**SITE FIRE ALARM PLAN**

**MUNSEY ELEMENTARY SCHOOL**  
**10 NEW PORTABLE CLASSROOMS**  
 BAKERSFIELD CITY SCHOOL DISTRICT  
 3801 BRAVE AVE. BAKERSFIELD, CA 93309

Released: **ADDENDUM 1**  
 CURTIS MCNALLY

SITE FIRE ALARM PLAN

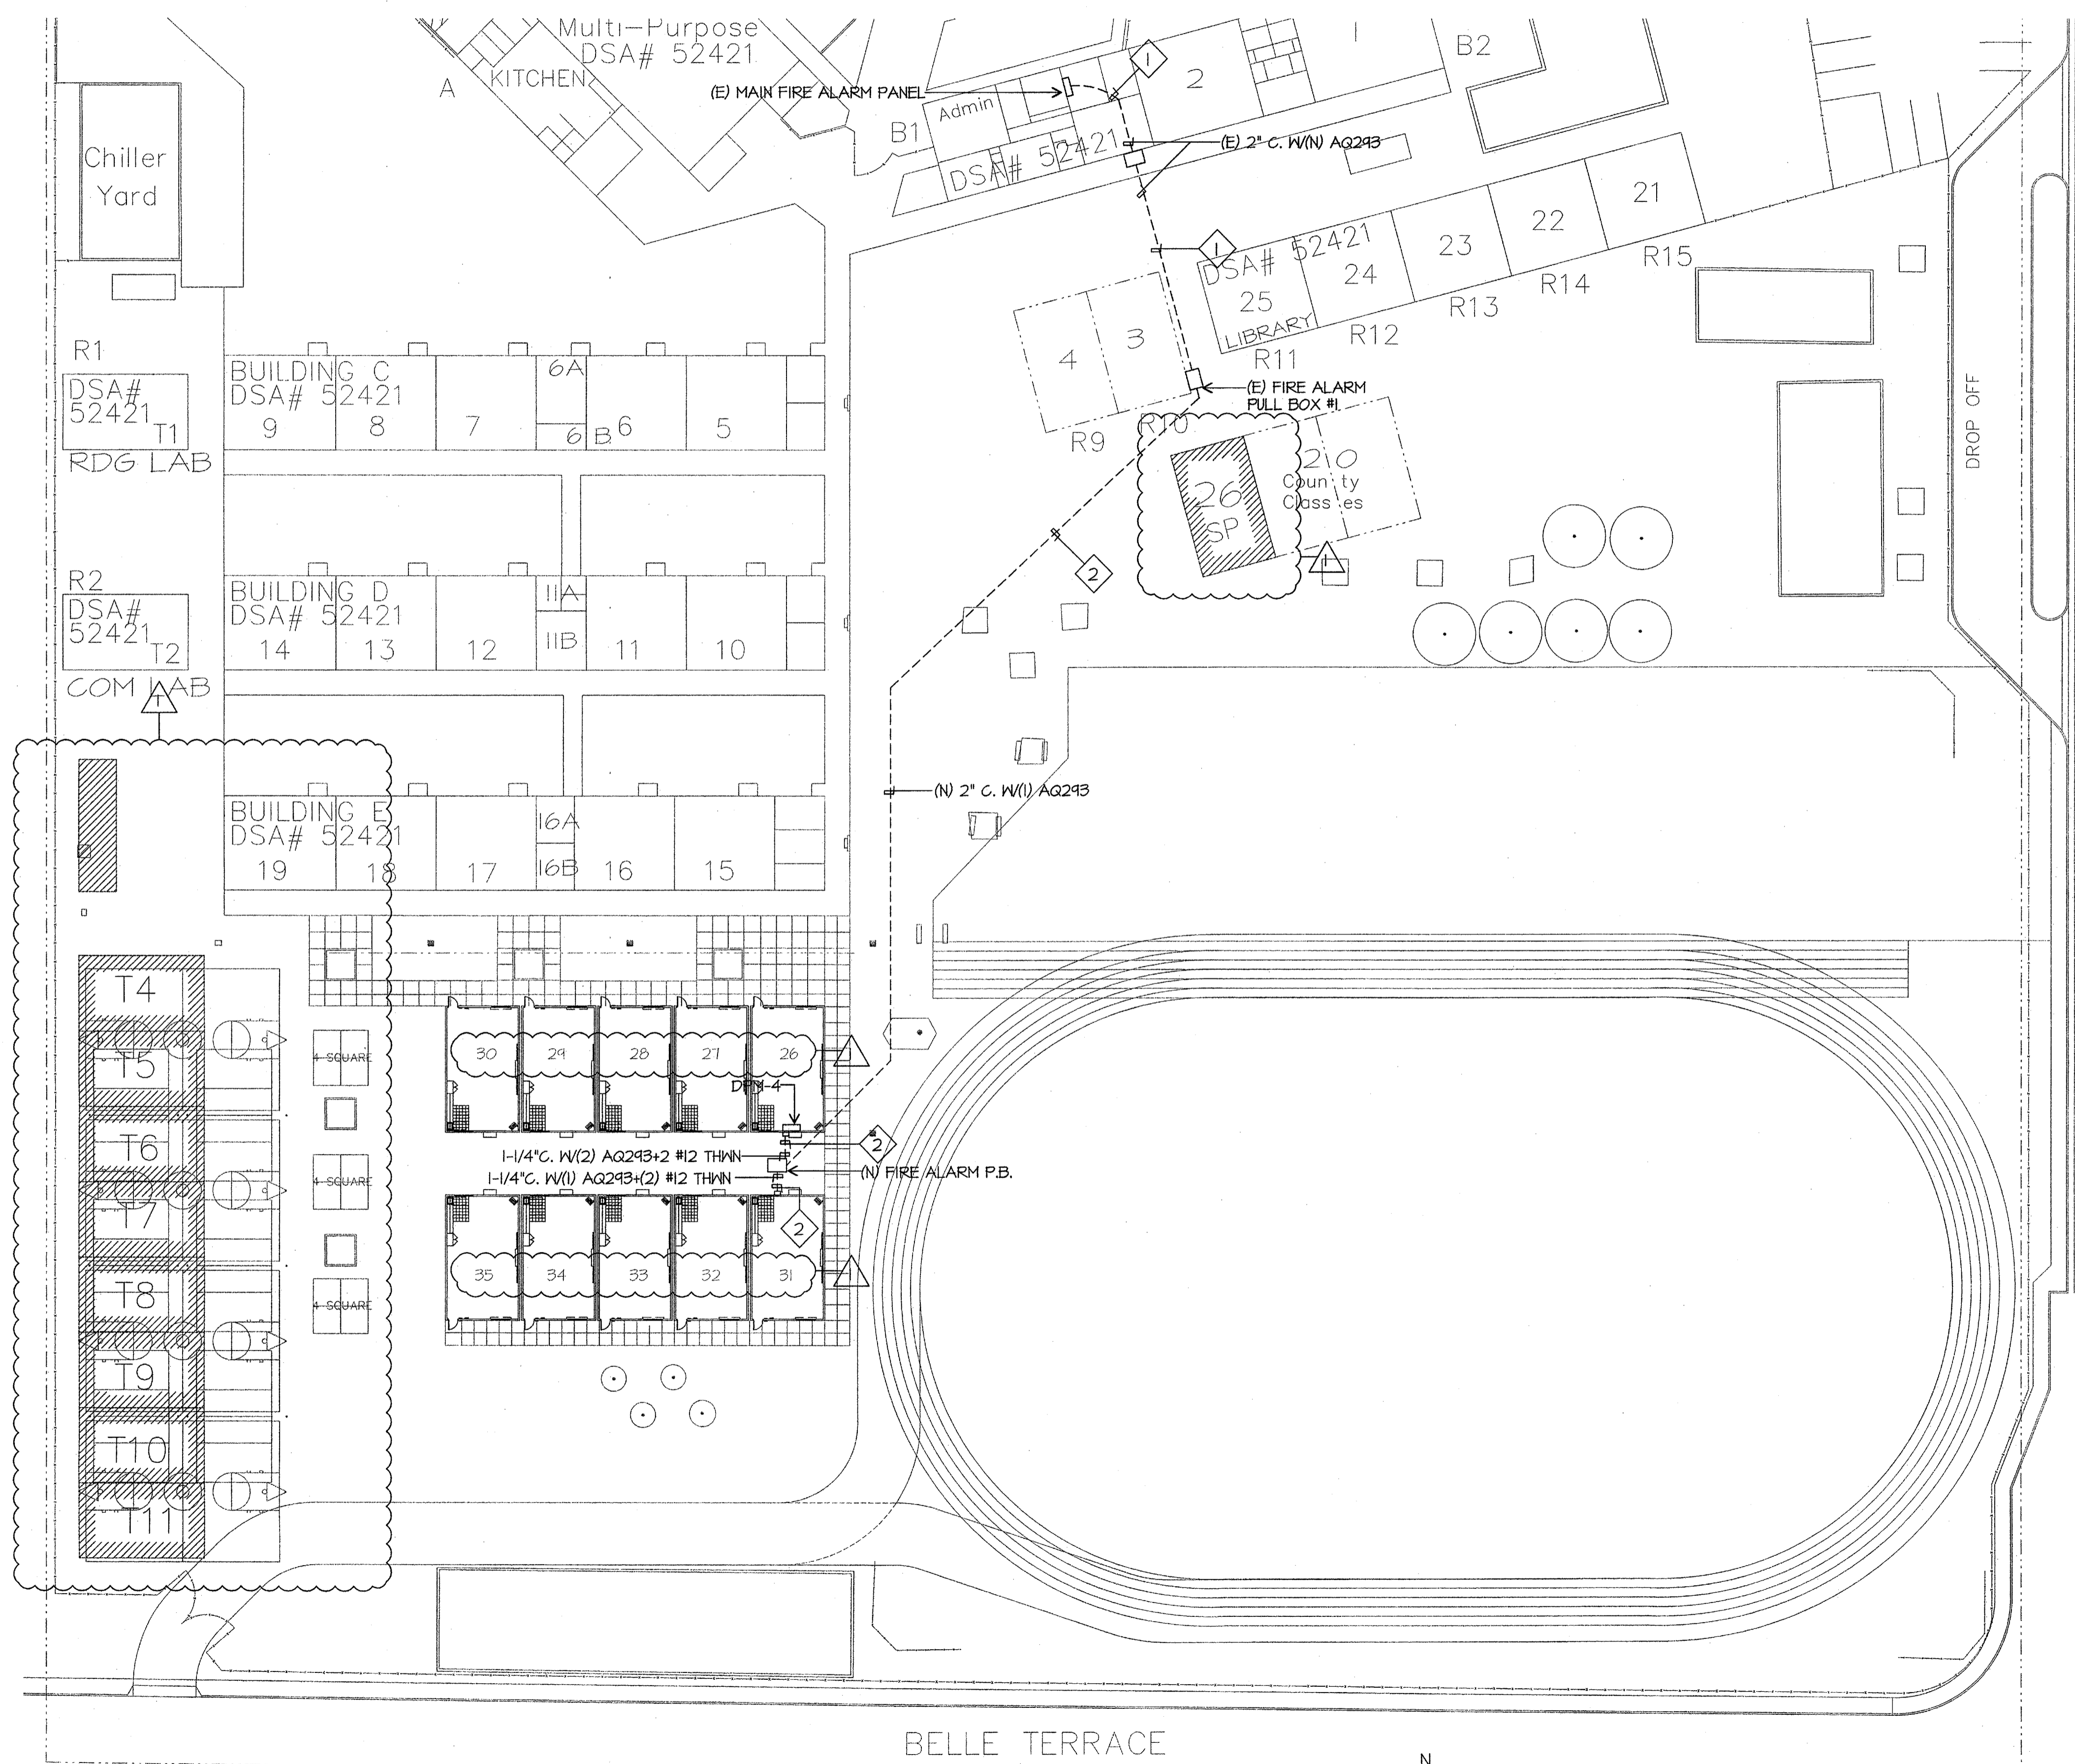
- 1 PULL NEW CABLES IN EXISTING CONDUIT. PULL PAST EXISTING CABLES.
- 2 SAWCUT AND REPAIR TO MATCH EXISTING. BORING IS AN ACCEPTABLE METHOD OF CONDUIT INSTALLATION. PROVIDE METHOD OF PROCEDURE FOR BORING TO ENGINEER FOR REVIEW AND APPROVAL. DETAIL BORING PROCEDURE. IDENTIFY TYPE OF CONDUIT TO BE USED IN BORE.
